COMMUNITY DEVELOPMENT DEPARTMENT REPORT

SUBJECT: Storyrock – AZ, MDA, PP, RZ
H-2025-0025

LOCATION: Generally located on the south side of W. Amity Rd., midway between S. Meridian Rd./SH-69 and S. Linder Rd., in the north 1/2 of Section 36, T.3N., R.1W

F. Annexation Legal Description & Exhibit Map – REVISED

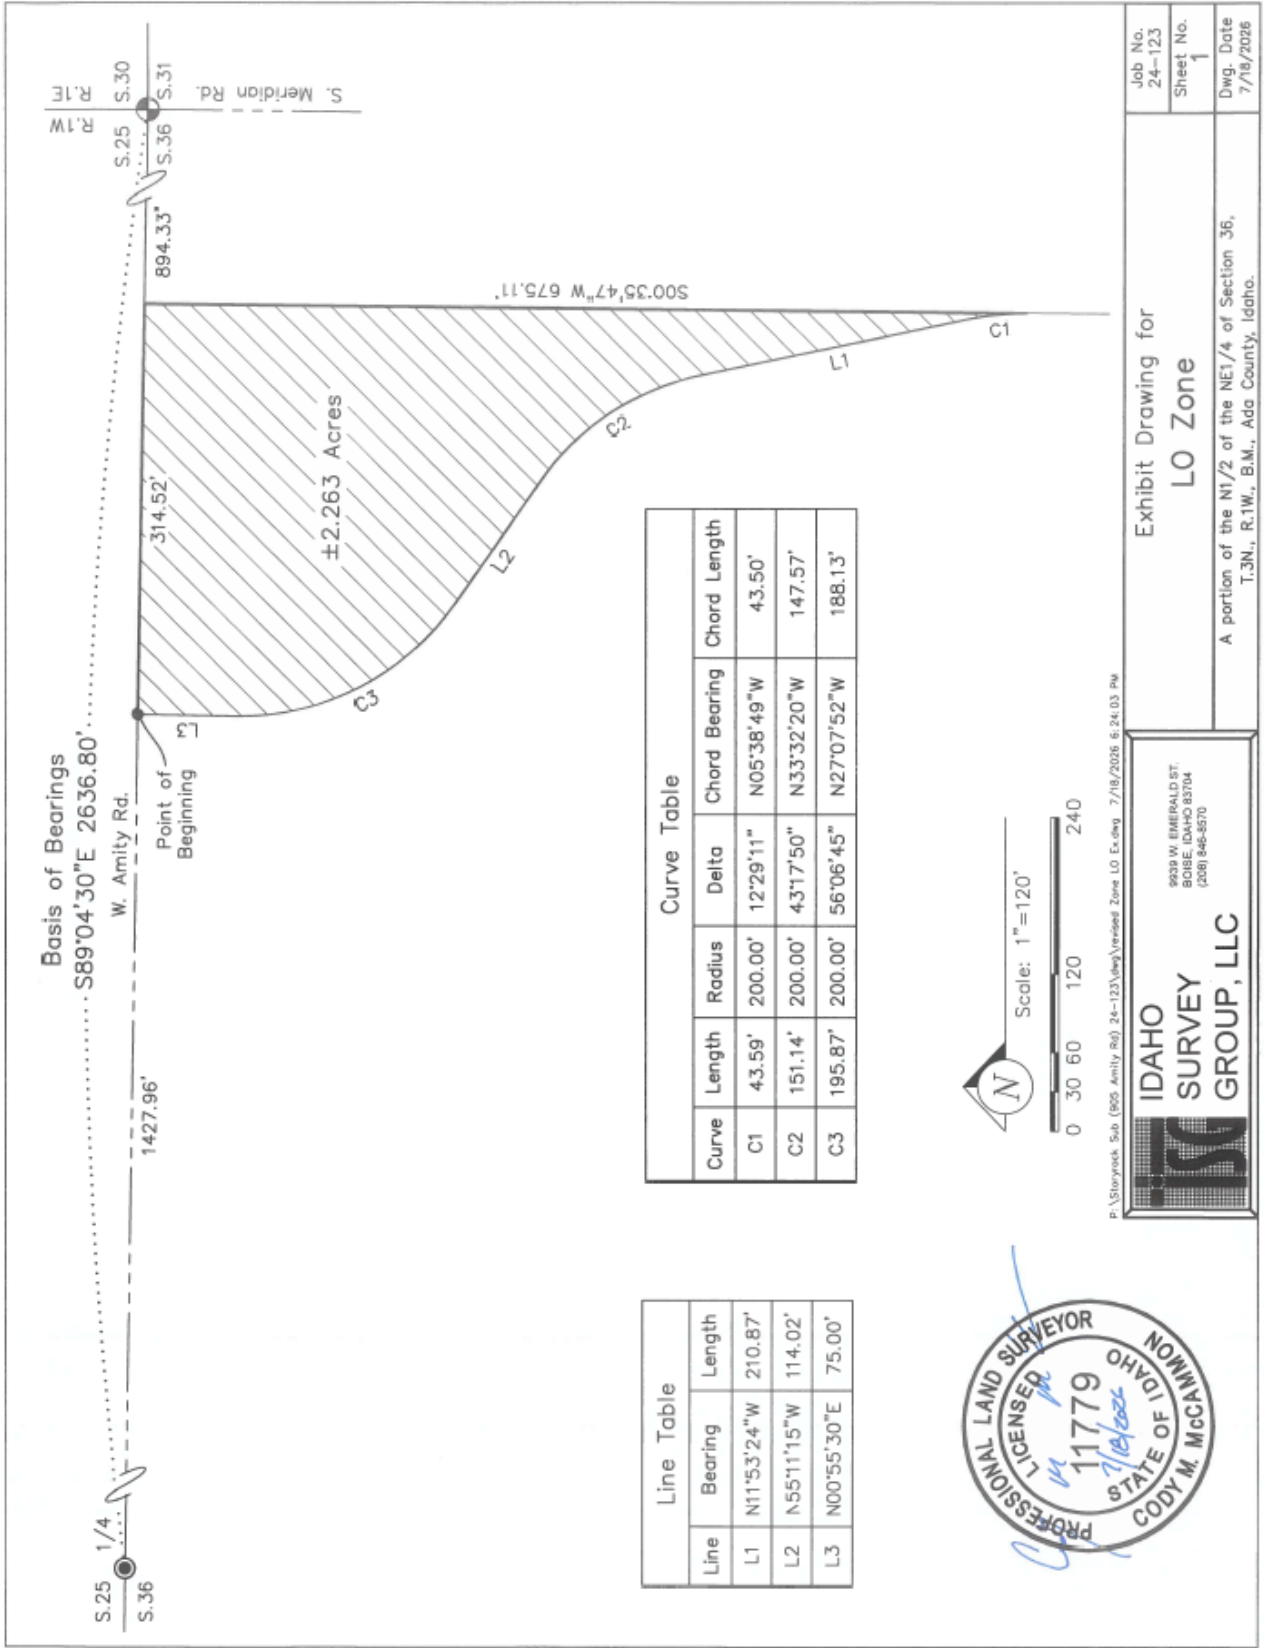
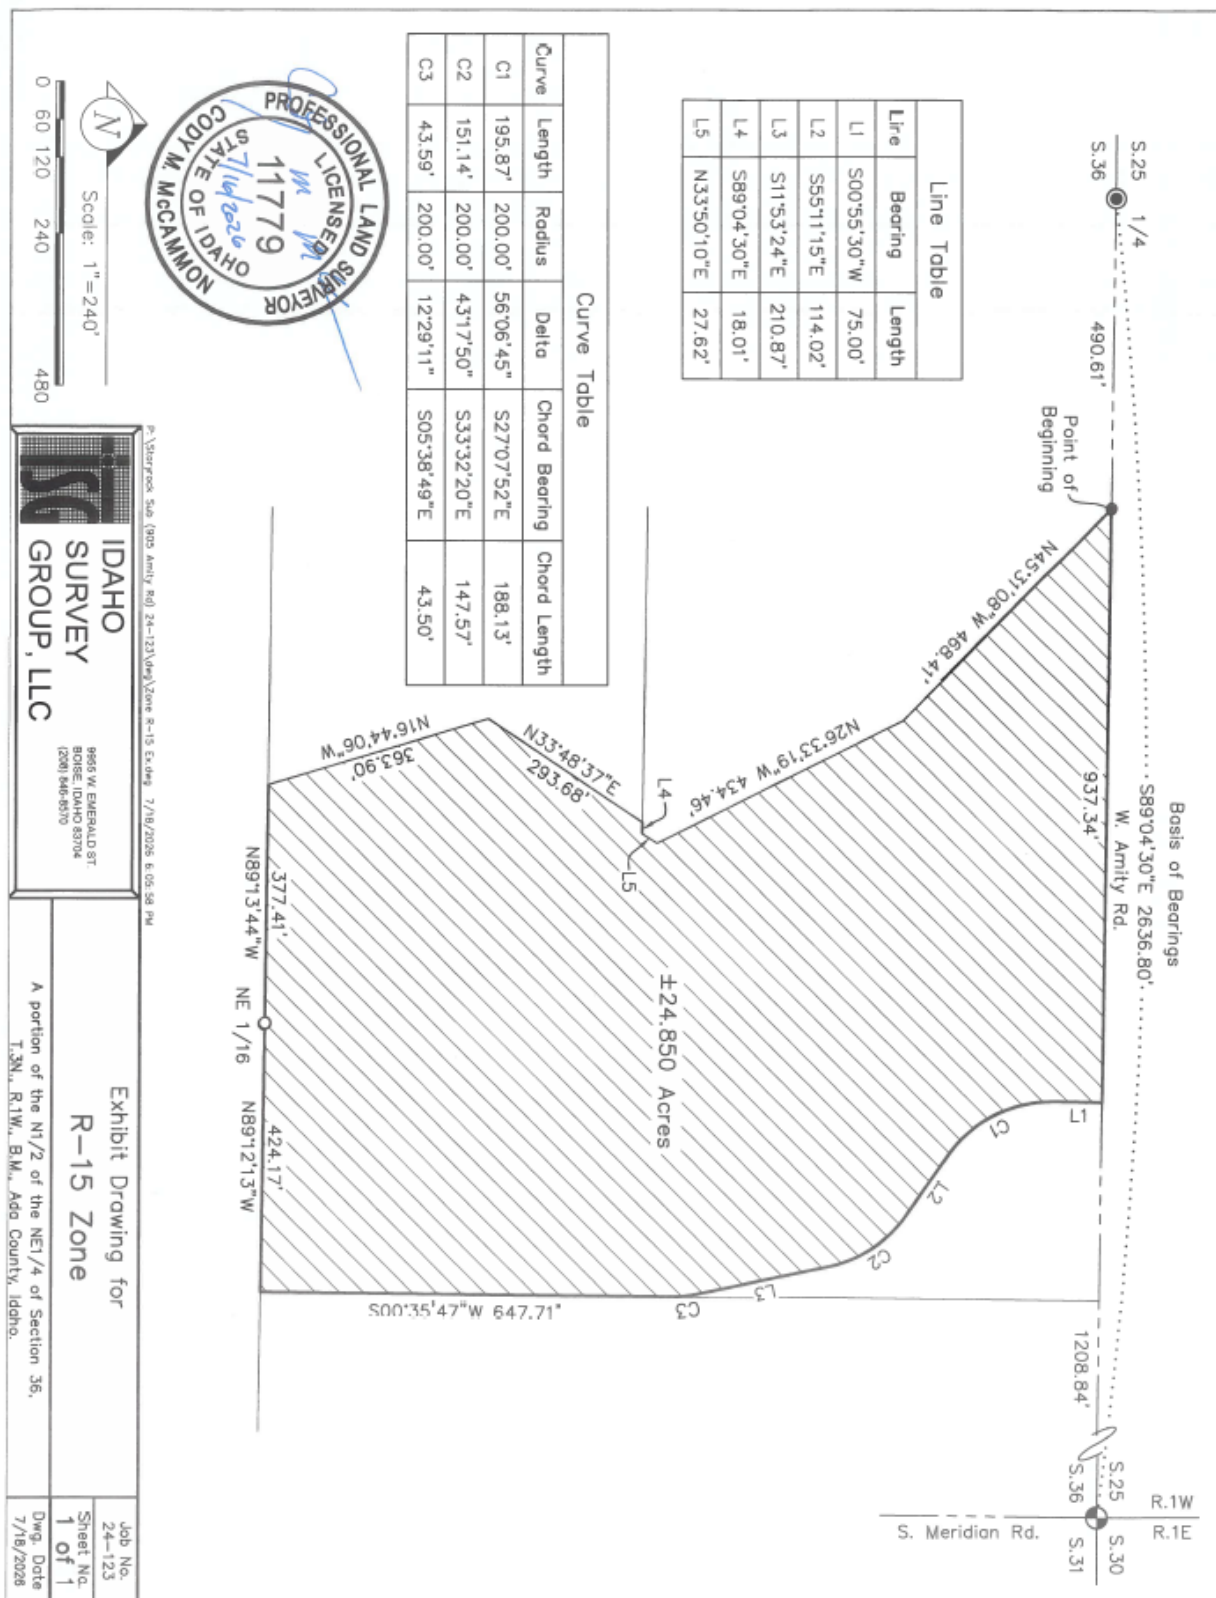
Because the property located at 455 W. Amity Rd. is designated Medium-Density Residential (MDR) on the Future Land Use Map (FLUM), Staff recommends zoning the property R-15 rather than L-O, consistent with the surrounding area and to facilitate future residential redevelopment consistent with the Comprehensive Plan. The existing use may continue as a legal nonconforming use within the R-15 zoning district, subject to the provisions of UDC 11-1B-4. Accordingly, the annexation legal descriptions and exhibit maps for the R-15 and L-O zoning districts should be revised prior to the City Council hearing. **The R-15 and L-O annexation legal descriptions and exhibit maps should be revised accordingly prior to the City Council hearing. *The zoning has been revised as requested.***

H. Preliminary Plat (dated: ~~8/12/2025~~ 7/8/2026) – REVISED

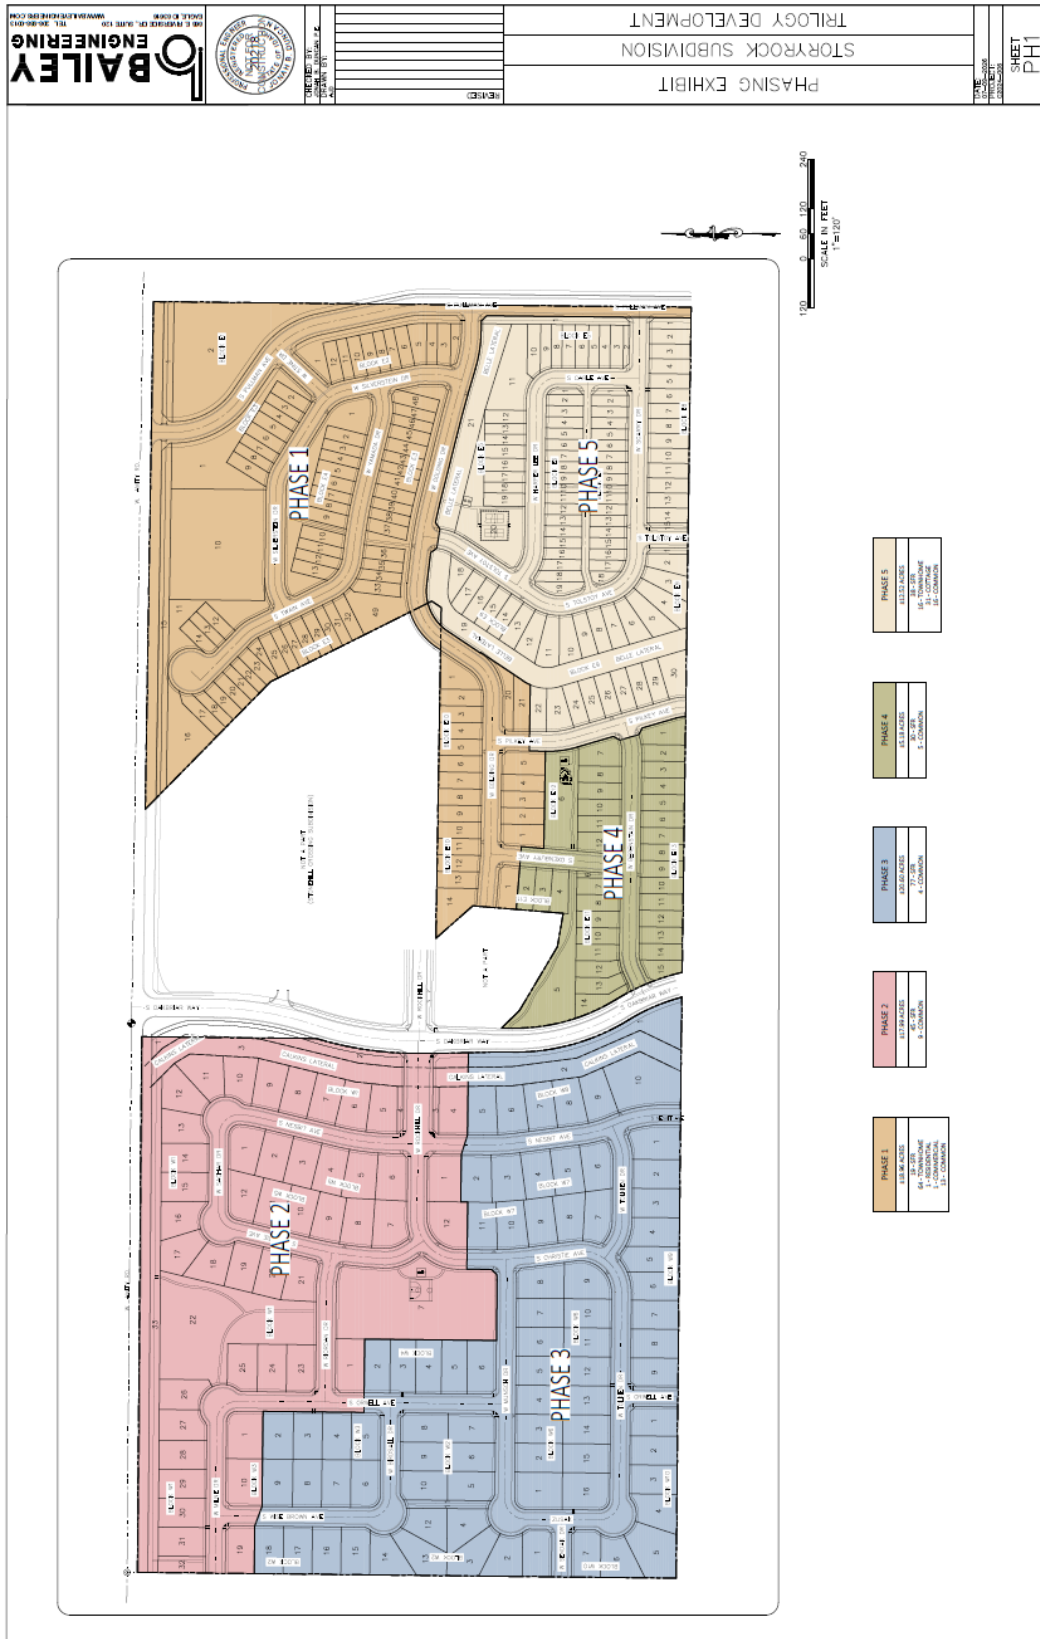
A preliminary plat is proposed consisting of 321 residential building lots for single-family detached and townhouse dwelling units, ~~2~~ 1 commercial office building lots and ~~44~~ 47 common lots on 75.13 acres of land in the R-4, R-8, R-15 and L-O zoning districts, as shown in the zoning exhibit above. The minimum lot size proposed is ~~2,600~~ 2,269 square feet (s.f.) with an average lot size of ~~5,392~~ 5,359 s.f. and a maximum lot size of ~~12,581~~ 12,580 s.f. *The Stonehill Crossing Subdivision preliminary plat included parcel #S1236120850 owned by Kent & Donna Mills Family Revocable Trust 06/06/2016 as Lot 1, Block 1; and parcels #S1236120876 &*

Where townhomes are proposed to span over lot lines, zero (0) setbacks should be depicted on the plat.

Micro-path lots are required to be a minimum of 20' in width in order to qualify toward the qualified open space requirement for linear open space. The plat and landscape plan should be revised accordingly.
